SUBJECT: SOURCE RANGE MONITOR MINIMUM COUNT RATE FOR STARTUP
(TAC NOS. 69296 AND 69297)

RE: PEACH BOTTOM ATOMIC POWER STATION, UNIT NOS. 2 AND 3

These amendments revise the minimum count rate required on the source range monitors for the withdrawal of control rods for startup.

SAFETY EVALUATION BY THE OFFICE OF NUCLEAR REACTOR REGULATION SUPPORTING

Figure 3.3.1

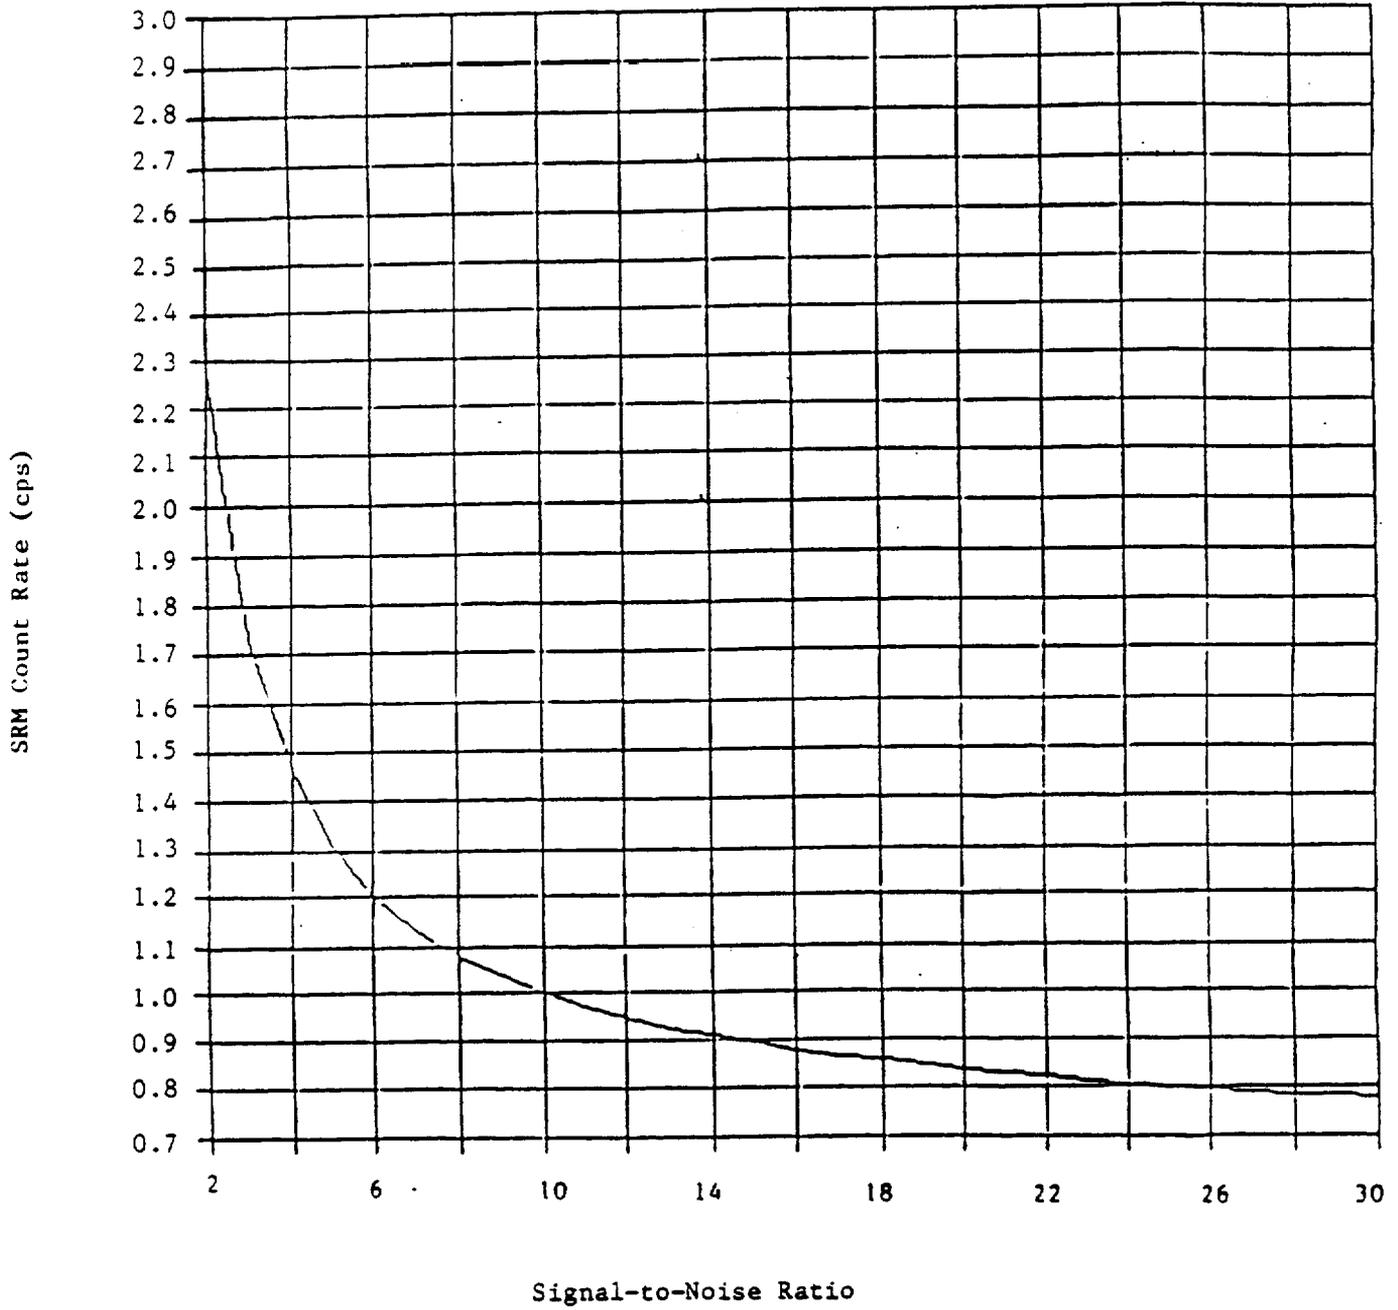
*May be reduced for startup only, provided at least three source range channels have an observed count rate and a signal-to-noise ratio on or above the curve shown on Figure 3.3.1.

The requirement of at least 3 counts per second (may be reduced for start-up provided the count rate and signal-to-noise ratio is on or above the curve shown on Figure 3.3.1) assures that any transient, should it occur begins at or above the initial value of 10^{-8} of rated power used in analyses of transient cold conditions. One operable SRM channel would be adequate to monitor the approach to criticality using homogeneous patterns of scattered control rod withdrawal. A minimum of two operable SRM's are provided as an added conservatism.

The proposed changes are to TS 3/4.3.B.4 and associated Bases. The changes add, via an asterisk marked footnote, a statement that the 3 cps requirements may be reduced for startups if three (vs two for the current specification) SRM Channels meet the limits on count rate vs S/N ratio provided in proposed TS Figure 3.3.1. As an example, a count rate of 0.8 cps is allowed if the S/N ratio is about 25 or more. Figure 3.3.1 is based on the new analysis by GE for PB2&3 of SPM downscale nominal trip setpoint vs S/N ratio.

SRM minimum count rates have previously been lowered for several reactors, with GE concurrence, to 0.7 cps with a S/N ratio of 2 for first cycle startup with weak neutron sources resulting from delayed schedules. GE later evaluated this reduction for reload cores (with increased noise) and found that an increased S/N limit is required to achieve the same probability of detecting real signals. This analysis was done at PECO's request (as a plant specific analysis) for PB2&3. This analysis (for SRM downscale trip setpoint determination) involves several assumptions about the signal and noise characteristics and probability requirements, and uses the new standard GE setpoint methodology for setpoint uncertainties. The assumed signal characteristics are straightforward and acceptable. A primary assumption is that there will be only a 5 percent probability of incorrectly detecting neutrons when they are absent and a 95 percent probability of detecting them when present. This is a reasonable criterion. The NRC review of these various assumptions and probability requirements, and of the analysis methodology concludes that an acceptable analysis has been developed to provide the SRM downscale setpoint and corresponding TS limit for SRM operability.

The review thus concludes that the proposed change to PB2&3 TS 3/4.B.4 (and Bases), providing an alternate limit for control rod withdrawal during startup when at least three SRM meet the limit of Figure 3.3.1, is acceptable. This approval is specific to the Peach Bottom units.

SRM Count Rate Versus
Signal-to-Noise Ratio

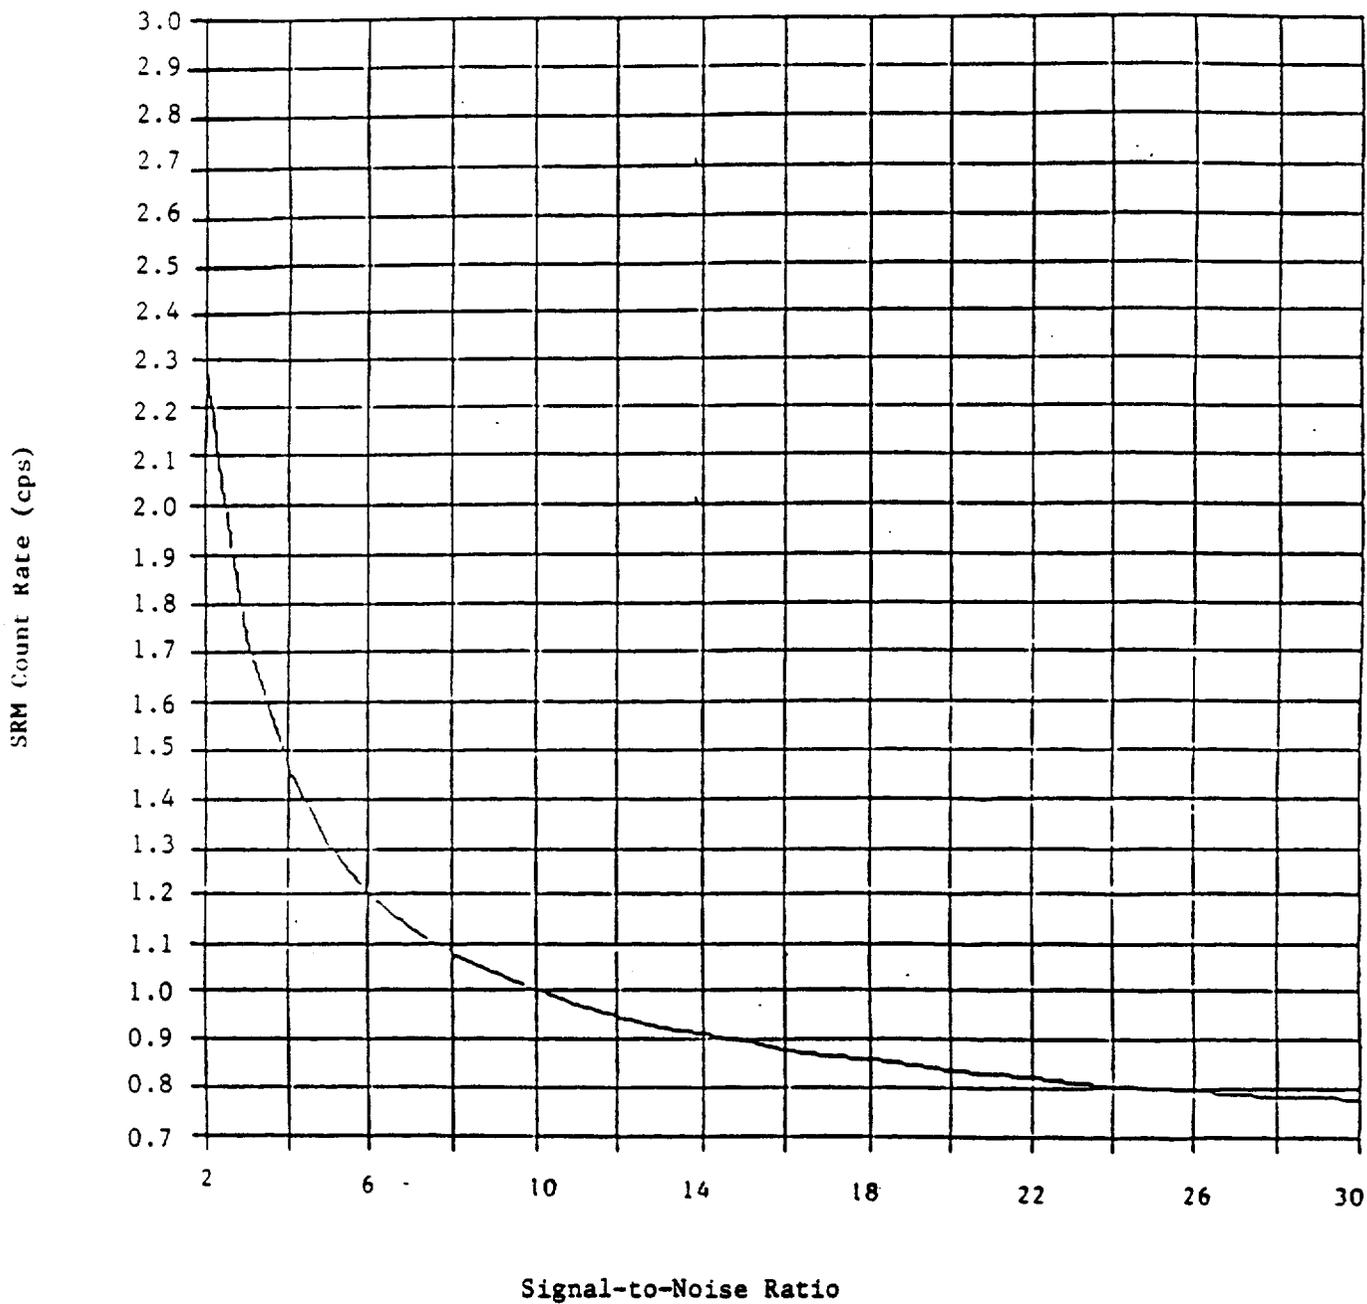
*May be reduced for startup only, provided at least three source range channels have an observed count rate and a signal-to-noise ratio on or above the curve shown on Figure 3.3.1.

The requirement of at least 3 counts per second (may be reduced for startup provided the count rate and signal-to-noise ratio is on or above the curve shown on Figure 3.3.1) assures that any transient, should it occur begins at or above the initial value of 10^{-8} of rated power used in analyses of transient cold conditions. One operable SRM channel would be adequate to monitor the approach to criticality using homogeneous patterns of scattered control rod withdrawal. A minimum of two operable SRM's are provided as an added conservatism.
